Illinois Department of Transportation

December 8, 2005

SUBJECT: FAI Route 94 & FAP Route 332
Project ACNHI-ACNHF-000S(471)
Section (0203.1 & 0312-708W)RS-3
Cook County
Contract No. 62108
Item No. 2P, December 16, 2005 Letting
Addendum A

NOTICE TO PROSPECTIVE BIDDERS:

TYPICAL PILASTER SUPPORT – PLAN VIEW

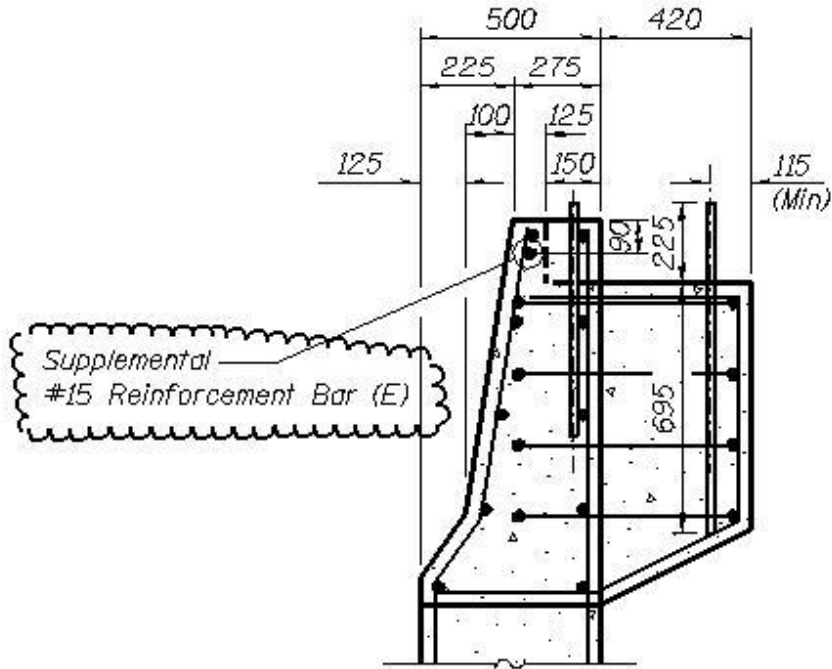
PILASTER SUPPORT MODIFICATION

Description: This work shall consist of constructing the pilaster supports according to the revised details included herein.

The changes to the quantities involved in the modifications of the pilaster supports are not reflected in the bills of materials or the summary of quantities; however the Contractor will be paid for the quantities actually furnished at the unit prices bid for the work involved.

EMERGENCY ACCESS DOOR
TOP VIEW

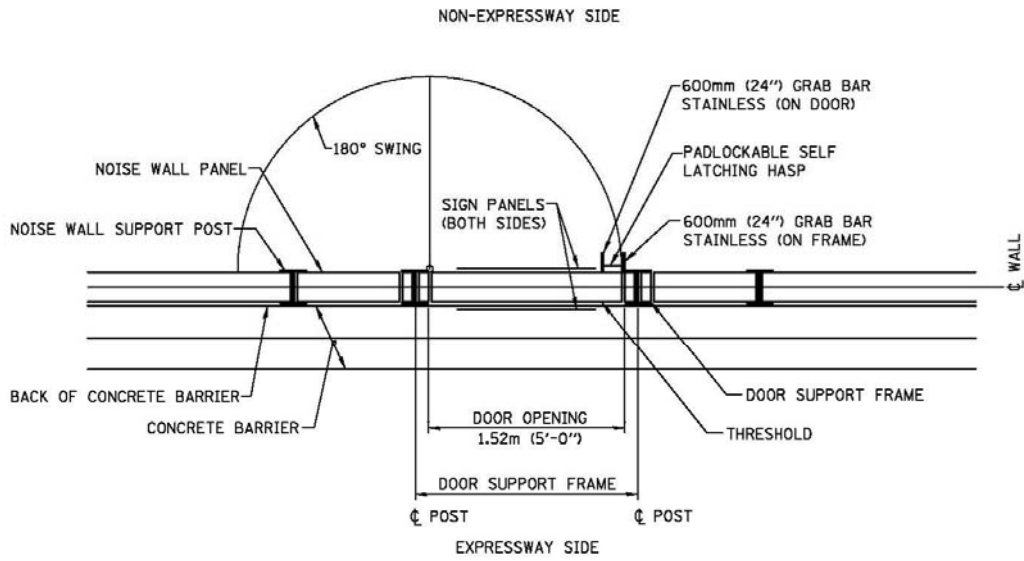
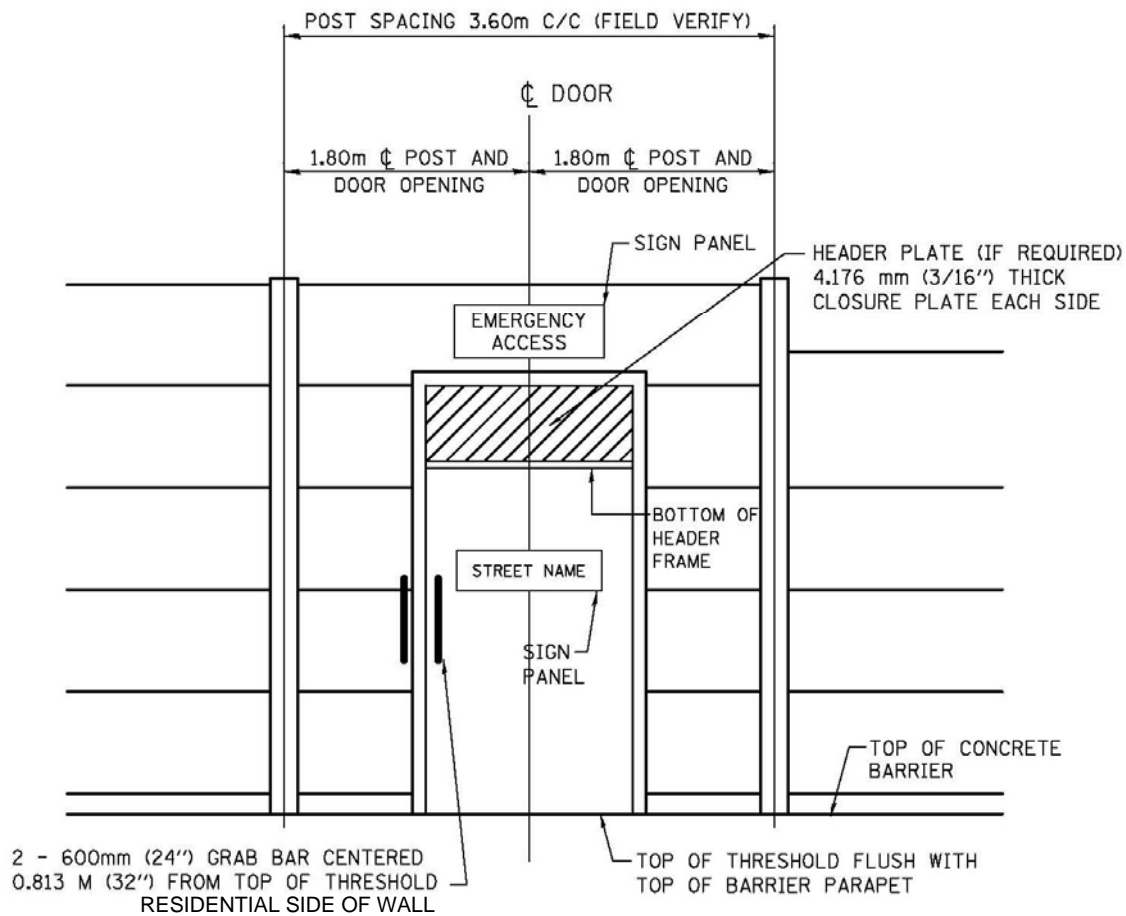
Emergency Access Doors:

Signing at each emergency access door: The Contractor shall furnish the signs, which are shown on the table included herein and shall install them on the noise wall or access doors as detailed in the plans.

All emergency access door materials, including steel doors, frames, finish hardware, attachments to vertical support posts and incidentals shall be included in the cost of the wall mounted sound barrier panels. All labor and materials required to erect and install emergency access doors shall be included in the unit cost for NOISE ABATEMENT WALL, STRUCTURE MOUNTED.
